REPORT SUMMARY MINOR VARIANCE APPLICATION FILE NUMBER A096/24

CITY WARD #:	3
APPLICANT:	Rabia Baqar
AGENT:	Anthony Del Grosso
PROPERTY:	300 Grand Vellore Crescent, Woodbridge
ZONING DESIGNATION:	See below.
VAUGHAN OFFICIAL PLAN (2010) DESIGNATION:	Vaughan Official Plan 2010 (,VOP 2010'): "Low-Rise Residential"
RELATED DEVELOPMENT APPLICATIONS:	None
PROPOSAL:	Relief from the Zoning By-law is being requested to permit a proposed pergola and reduced landscaping requirements in the rear yard.

Urban Engineering & Project Management Services 346 Newkirk Road, Unit 9. Richmond Hill, Ontario L4C 0A9, 905.884.4336 PROP. IN-GRND. POOL SITING AND GRADING

LOT NO. : 47 REGISTERED PLAN 65M-3921 STREET NAME / No.: 300 GRAND VELLORE CRES. c/o RAINBOW CONTRACTING

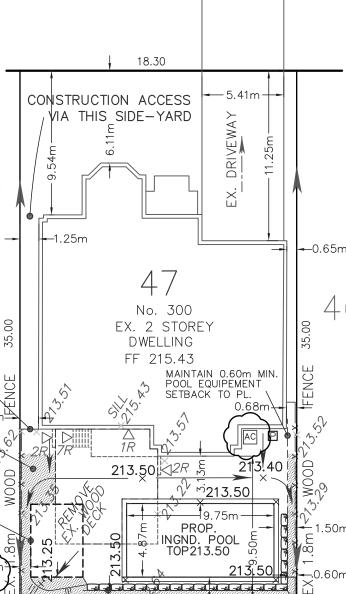
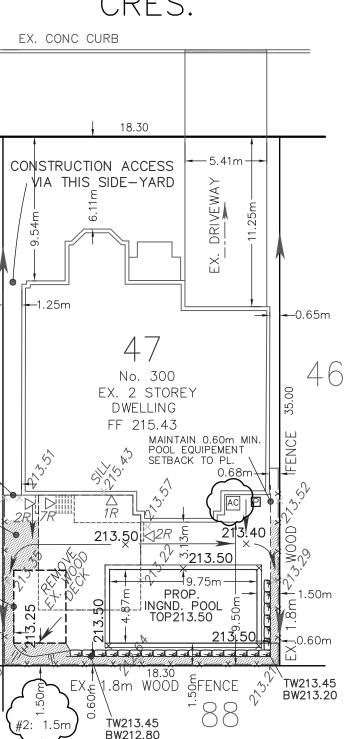
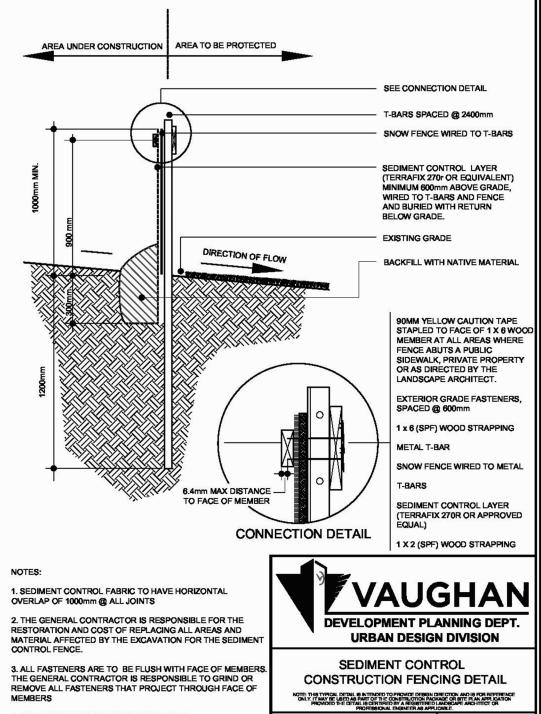
Due to the size of the proposed pergola on the subject property, which measures 16.63 m², the Owner/Applicant must acquire a Lot Grading Permit from the Development Inspection and Lot Grading Division of the City's Development Engineering Department. It's important note that any in-ground structure exceeding 10 m² necessitates a Grading Permit. Once the Grading Permit is obtained, please reach out to the Development Engineering Reviewer to clear the Condition imposed on this application. The Development Engineering Department does not object to the Minor Variance

Zoı	Zoning Bylaw 001-2021 Comments and General Comments		
1	The applicant shall be advised that additional variances may be required upon		
	review of detailed drawing for building permit.		
2	The Applicant advises that the pergola will have a height of 2.88 m.

However, I question the amount of front yard lawn that is being replaced with what appears to be hard surface materials.

Is there a minimum amount of soft landscaping coverage for front lawns and will Vaughan inspect the front yard for conformity with the by-law requirements?

application A096/24, subject to the following condition(s): **Development Engineering** The Owner/Applicant shall submit an application and **Recommended Conditions of** obtain an approved Grading Permit before initiating any Approval: work on the property. The Final Lot Grading and/or Servicing Plan will be required for the Grading Permit Application. Please visit the Permits page of the City of Vaughan's website: Permits | City of Vaughan to apply for a Grading Permit. For any inquiries regarding the Grading Permit, please email DEPermits@vaughan.ca
